CUSTOMER LETTER

RE: IMPORTANT SAFETY RECALL INFORMATION REGARDING YOUR MOTO GUZZI NORGE 1200 MOTORCYCLE

Repair Instructions:

Fig. 2

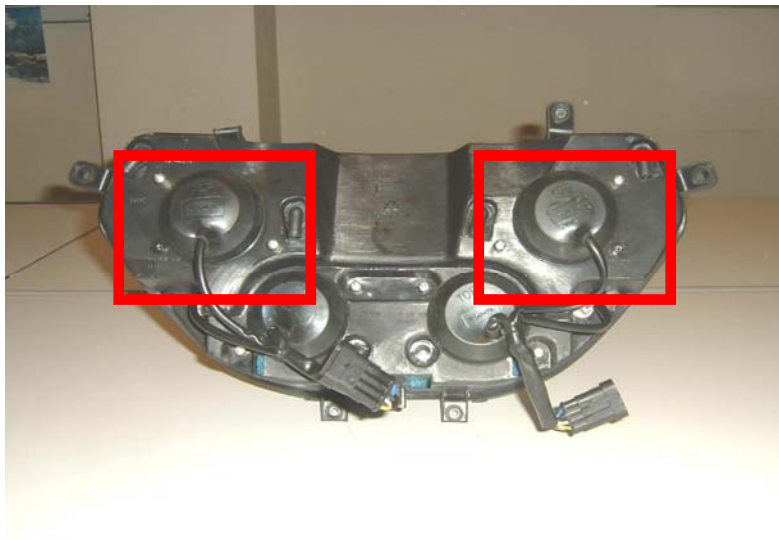
Uncover the cable harness of the low-beam lamp by pulling the black protective hoods off the assembly (**fig. 2 and 3**).

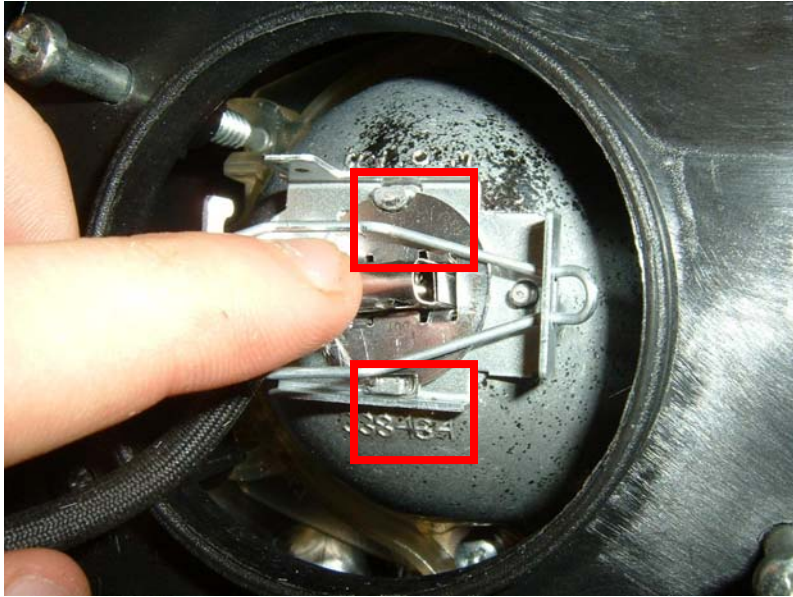
Remove the lamp and replace it with new lamp (code 981082). Align the bulb in the socket as shown, matching the design to the respective bulb cut-out.

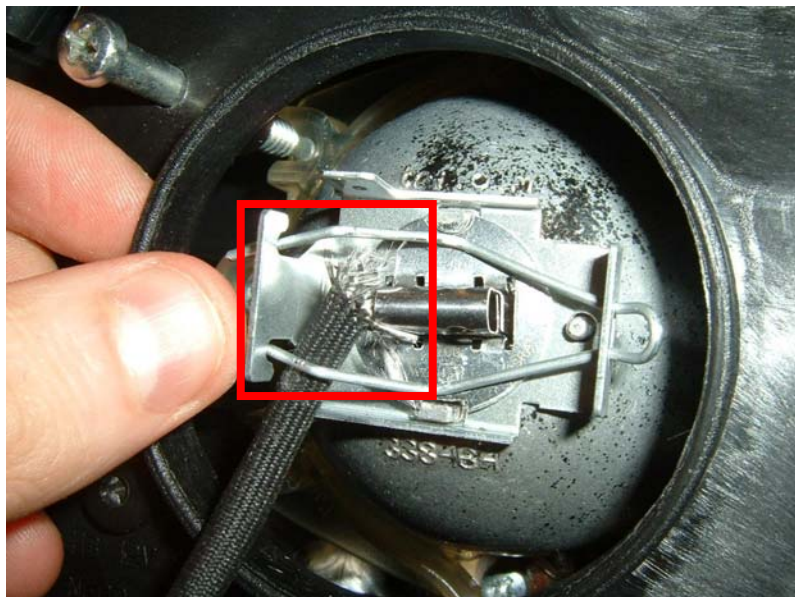
When remounting, make sure the cable harness goes under the lock fork as illustrated in the following picture.
